18 Sandfield Road - Application for Fence Exemption

Date: May 27, 2026

From: District Manager, Municipal Licensing and Standards, Central District

Attachment 3: South side perimeter entry fence is not self-closing.

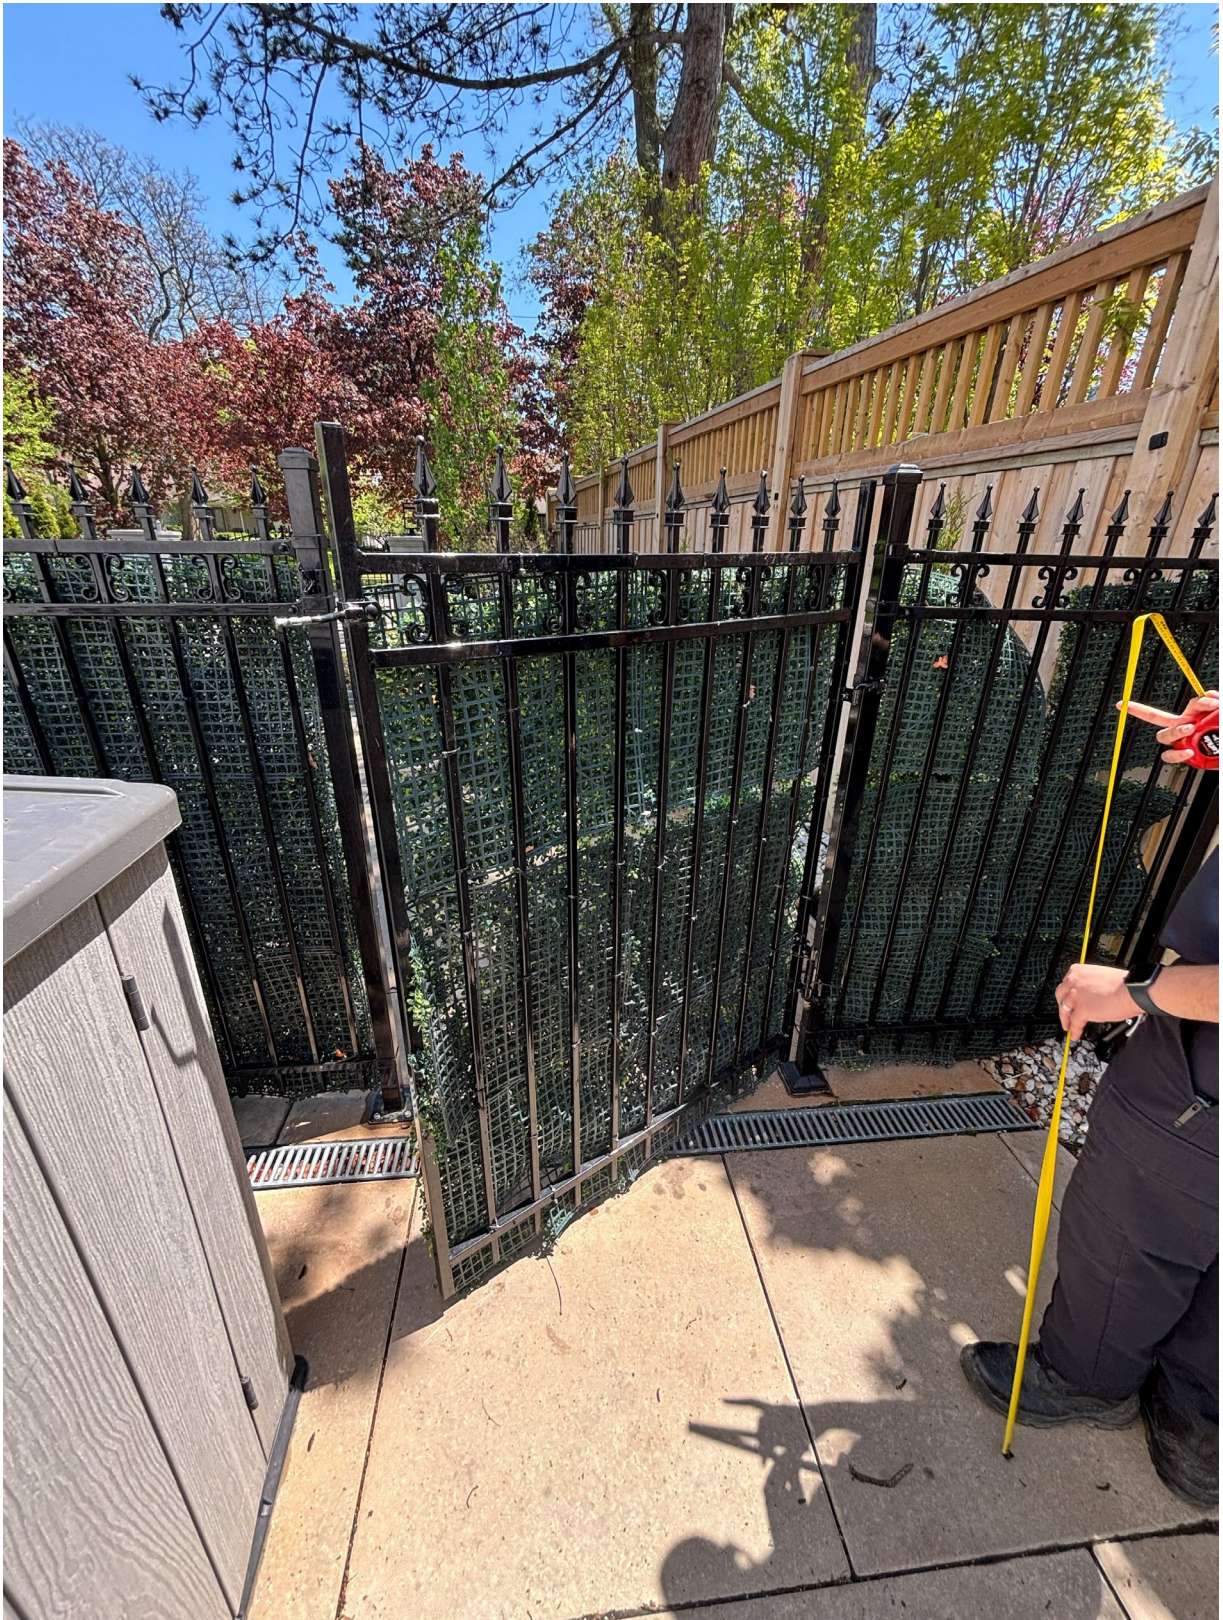
Rear Yard	Rear Yard – south side perimeter gate access to pool/backyard	South side perimeter gate is not self-closing.	Chapter 447 - 1.3 Section C. (6)(c)(1) Access Protection. Every gate in a swimming pool enclosure shall: If it is a single gate: Be self-closing and equipped with a lockable, self-latching device located on the inside near the top of the gate or on the outside at least 1.5 meters above grade
